TECHNICAL MEMORANDUM

PEER REVIEW OF SACRAMENTO VALLEY FINITE ELEMENT GROUNDWATER MODEL (SACFEM)

U.S. Bureau of Reclamation

October 2011

Figure 25. Net Stream Gain/Loss for Feather River Below Shanghai Bend and at Nicolaus

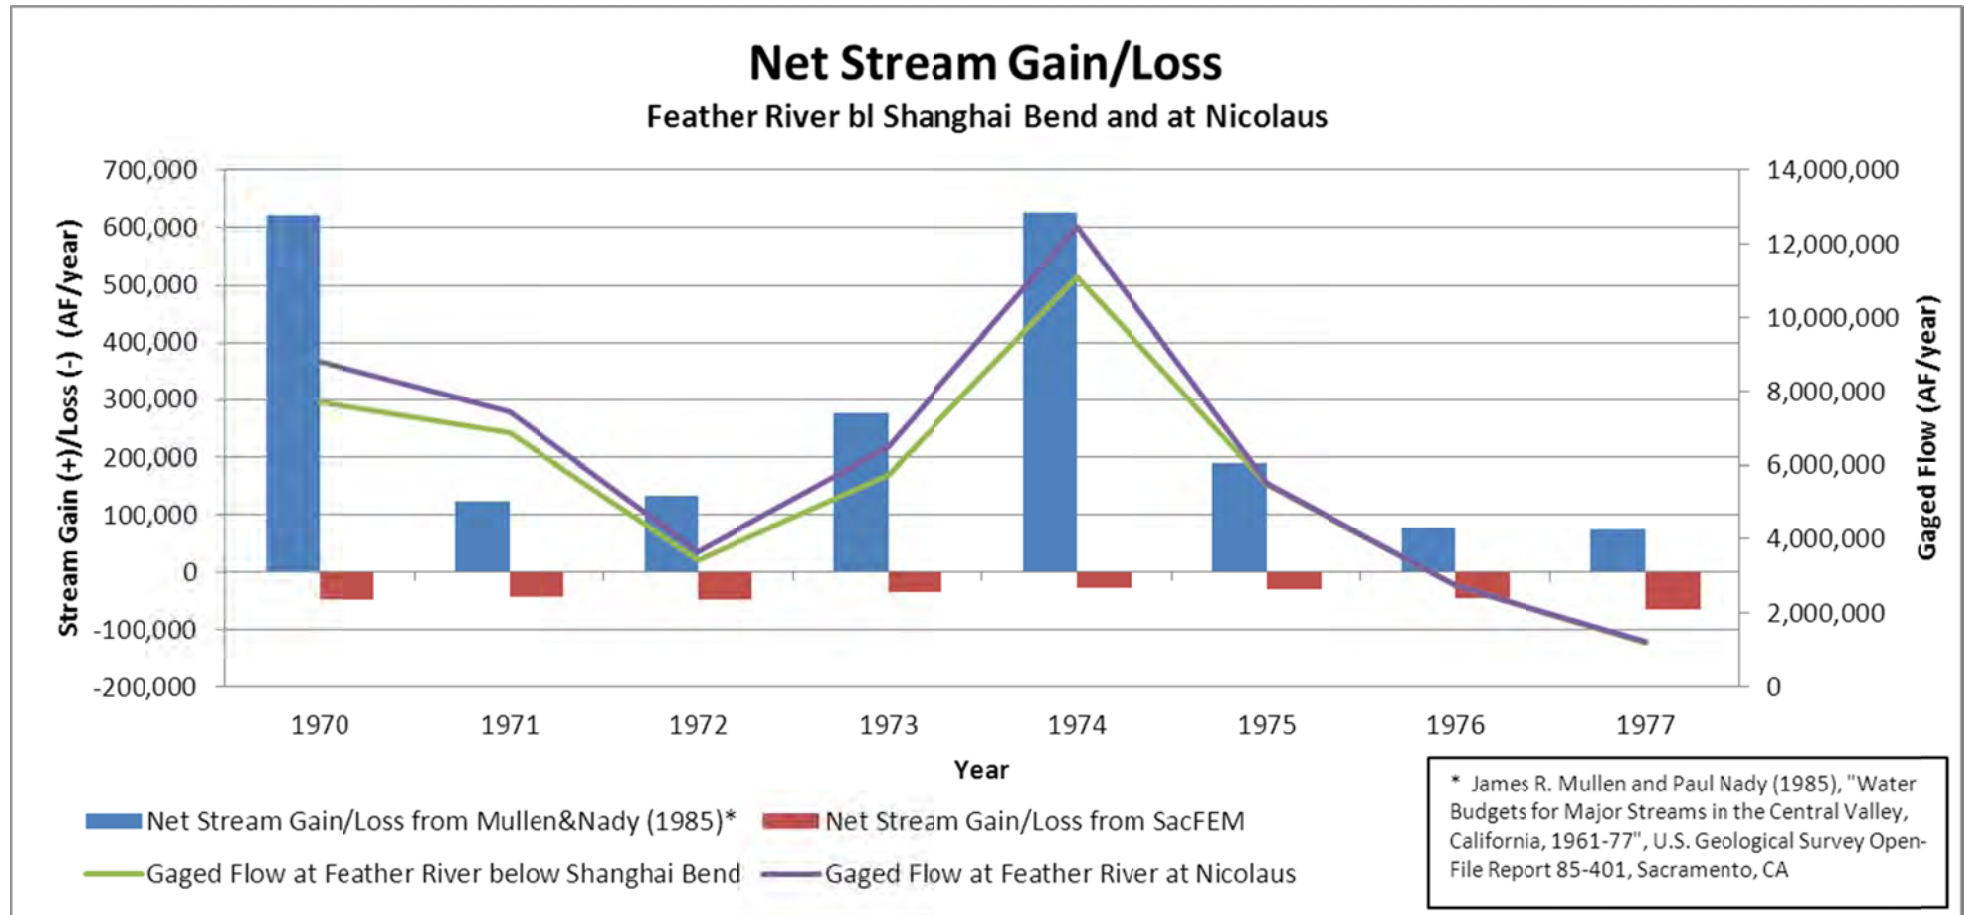
Feather River – Estimates of net stream gains and losses for Feather River below Shanghai Bend and at Nicolaus are provided in Figure 25. The USGS study estimates this section of Feather River as a gaining reach, while SacFEM consistently shows losses. SacFEM losses are overestimated in dry years.

In the absence of stream stage data, adjustments of streambed resistances during the calibration process are used by some modeling efforts to fine tune the stream-aquifer interaction. However, for SacFEM the surface water stage fluctuations and groundwater level fluctuations are large enough to make a difference in stream gains and losses calculations and show that the assumption of constant stream stage is not valid. It is recommended that SacFEM use temporally varied stream stages on a monthly time step based on monthly streamflows. It is also recommended that the variable stream stages of regulated streams be revised for each SacFEM application scenario. Adjustment of streambed resistances may be used during SacFEM calibration after the stream stage data are incorporated in SacFEM input data files.

Figure 26. Net Stream Gain/Loss for Stony Creek below Black Butte Dam and Near Hamilton City

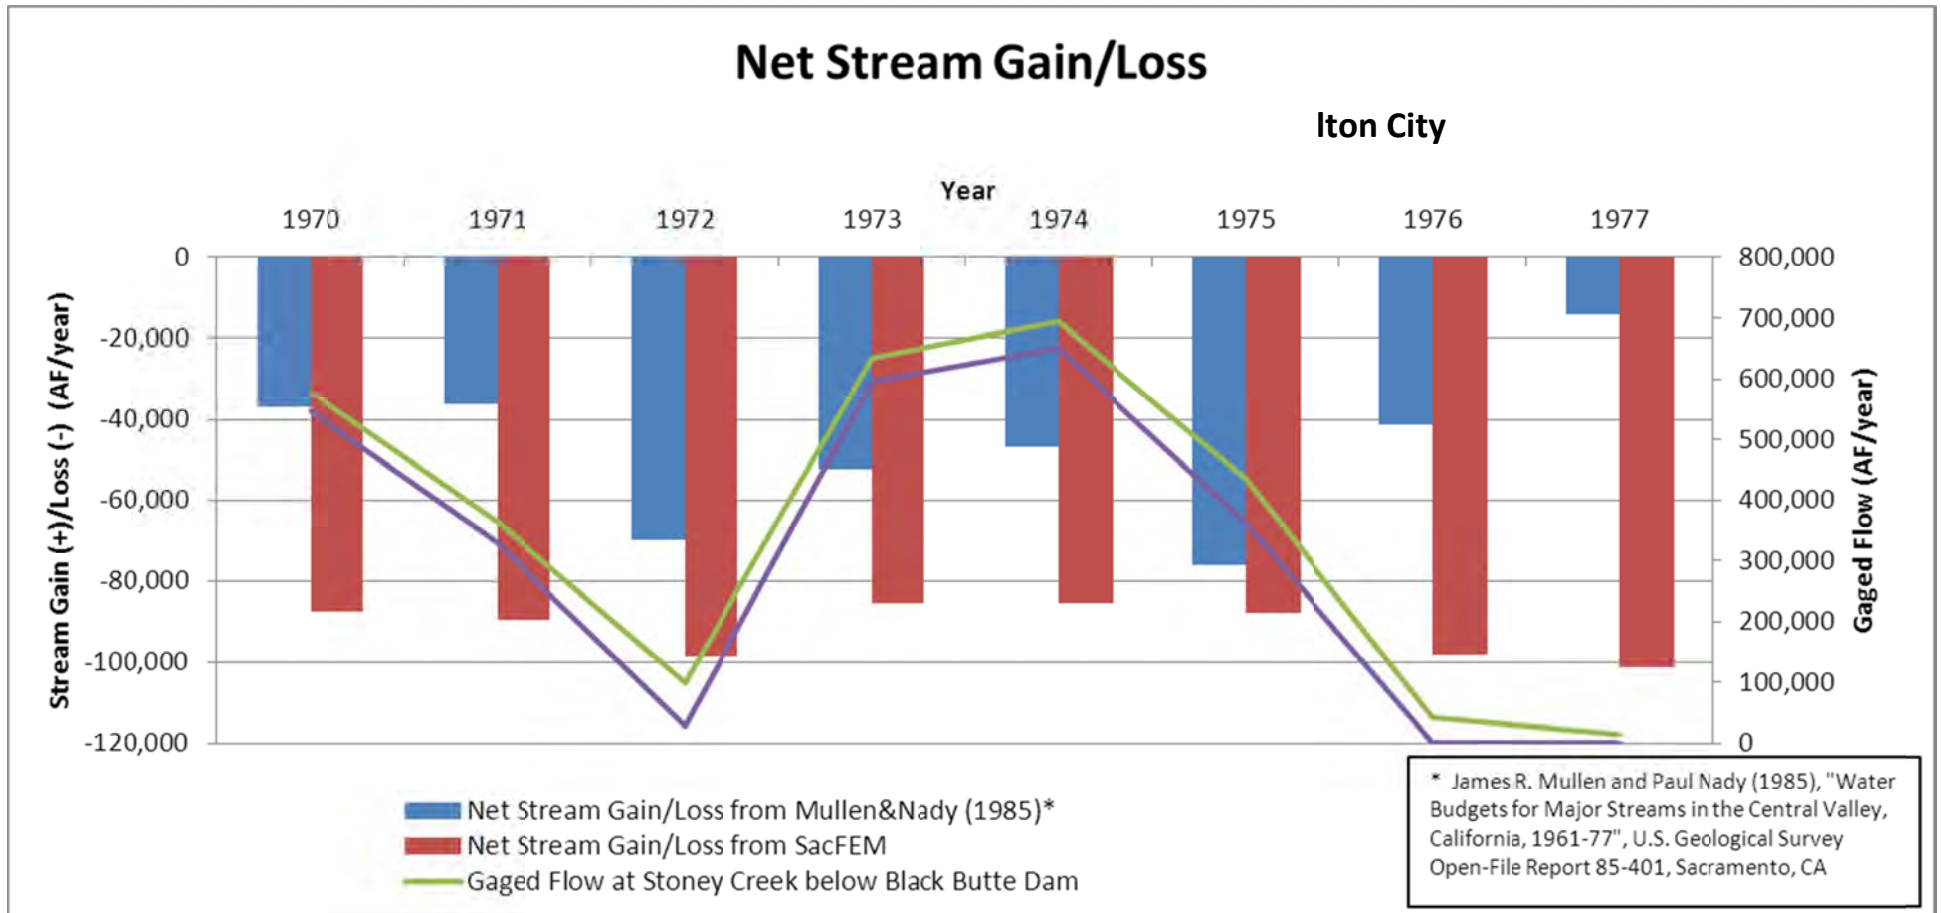
Stony Creek – Stream gains and losses for Stony Creek below Black Butte Dam are compared in Figure 26. The USGS study and SacFEM show that this is a losing stream year round; however, SacFEM losses are consistently overestimated. There were near zero flows in 1972 and 1976-1977, but SacFEM estimates of stream losses are highest for these years.

Figure 28. SacFEM Transient Calibration Scattergram from SacFEM Documentation (Lawson, 2009).

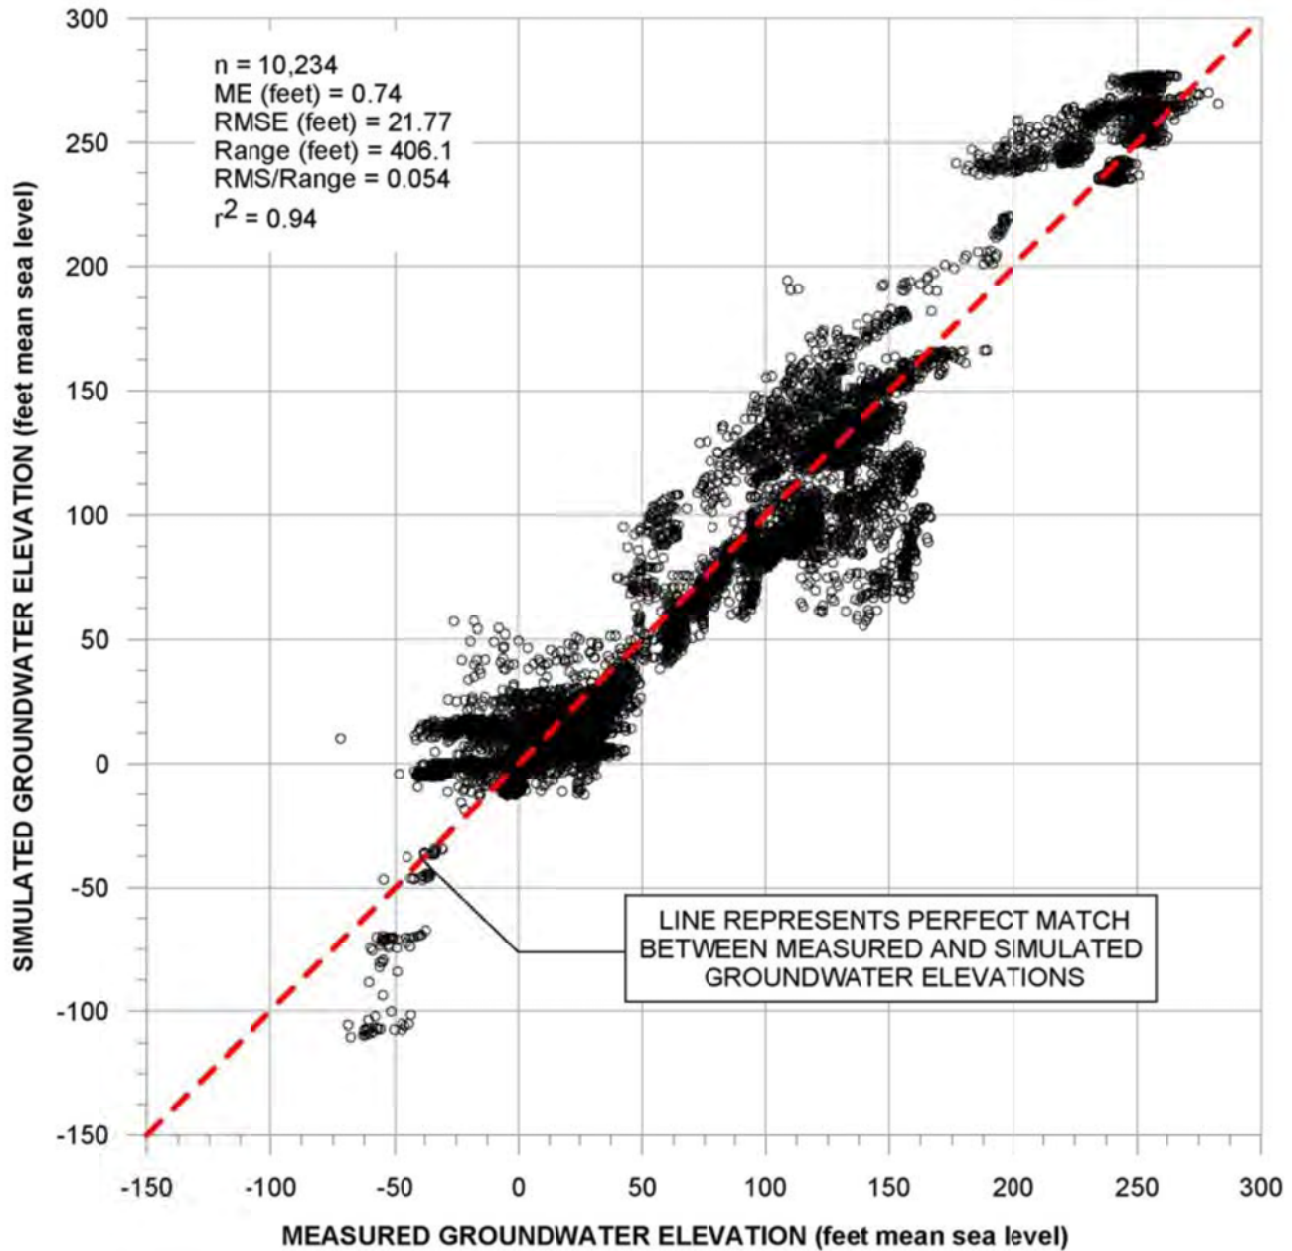
The matching status of the SacFEM calibration wells is provided in Table 5 and the scattergram of Figure 28. The long-term trend is not matched in twelve (12) out of the 41 long-term calibration wells. Seven (7) of the long-term calibration wells are in the vicinity of the urban areas of Sacramento, Woodland, and Chico.

There are more than 20 feet of differences between observed and simulated groundwater elevations for sixteen (16) of the 24 short-term calibration wells. Approximately half of the short-term calibration wells are located in western Placer and southern Sutter Counties, and more than 20 feet of head differences is obtained for each of these short-term calibration wells. Additionally, there are very limited long-term calibration wells in this area.

Figure 31. Transient Calibration Hydrograph for Well 43
 (Layer 1) – Central Glenn County, West of Sacramento River
 (Blue markers and grey line represent observed and simulated groundwater elevations, respectively)

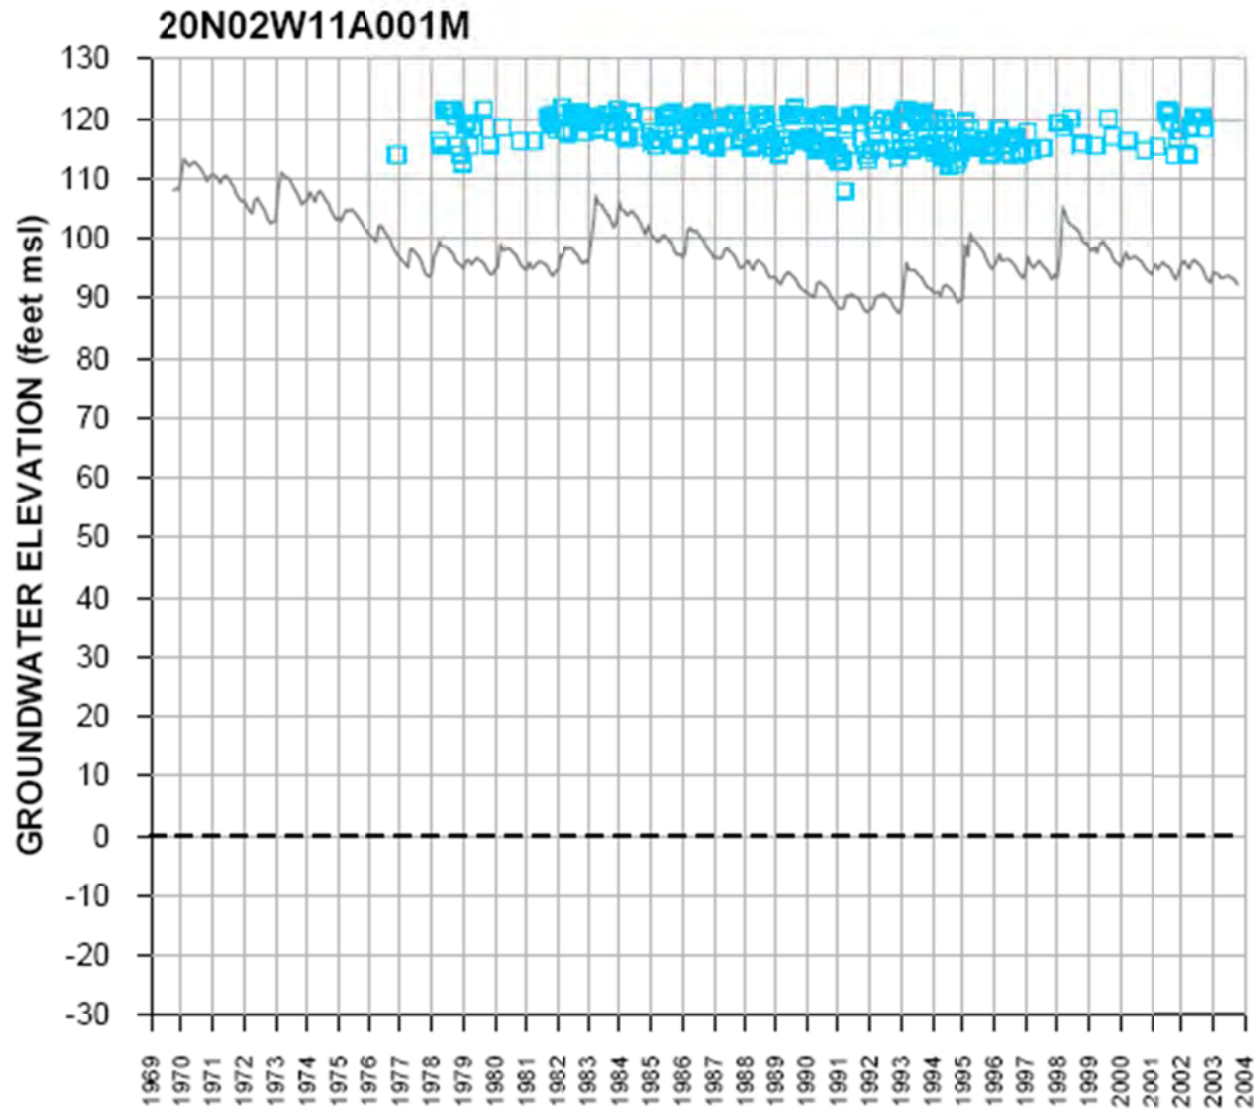
Simulated groundwater elevations for Calibration Well 43 are approximately 20 feet below observed groundwater elevations (Figure 31). This well is in an agricultural area with rice as the dominant crop. Water demand is met by surface water supply, with no groundwater pumping. High streambed resistances are used for nearby rivers and streams.

Figure 32. Transient Calibration Hydrograph for Well 40
 (Layer 3) – Southern Glenn County, West of Sacramento River
 (Blue markers and grey line represent observed and simulated groundwater elevations, respectively)

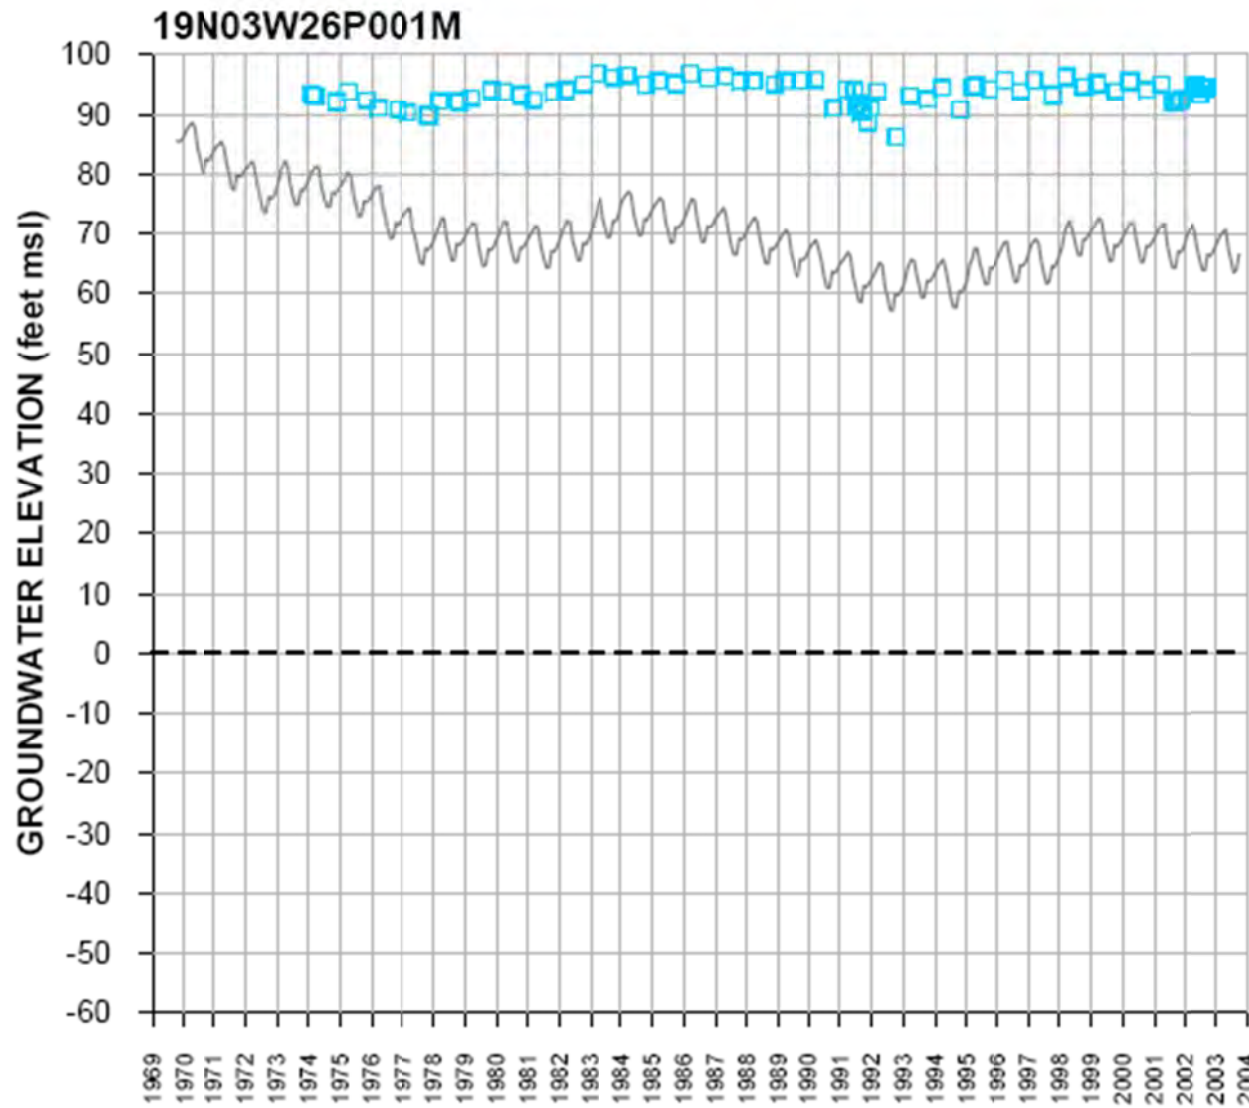
Calibration Well 40 has simulated groundwater elevations that are approximately 30 feet below the observed groundwater elevations (Figure 32). This well is also in an agricultural area with rice as the dominant crop. Water demand is met by surface water supply and low groundwater pumping. High streambed resistances are used for nearby rivers and streams.

Figure 33. Transient Calibration Hydrograph for Well 25
 (Layer 2) – Southern Colusa County, West of Sacramento River
 (Blue markers and grey line represent observed and simulated groundwater elevations, respectively)

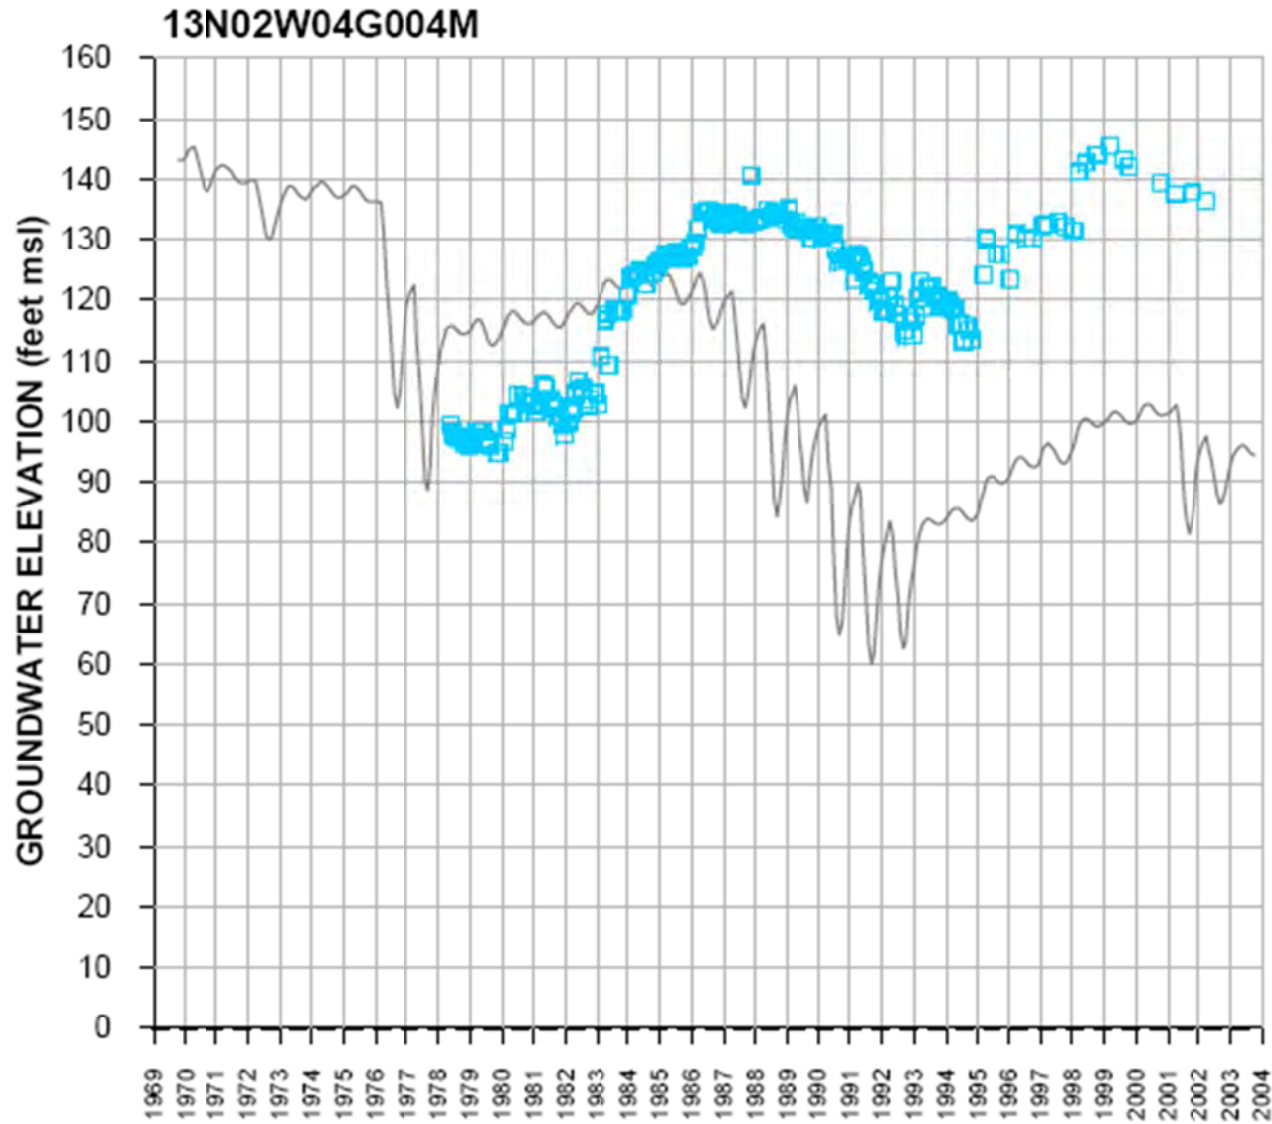
Recent trends in water levels are matched by Well 25; however, the simulated groundwater elevations are approximately 40 feet lower than the observed values (Figure 33). This well is in an agricultural area with orchards as the dominant crop. Water demand is met by surface water supply, with no groundwater pumping. Mixed streambed resistances are used for nearby rivers and streams.
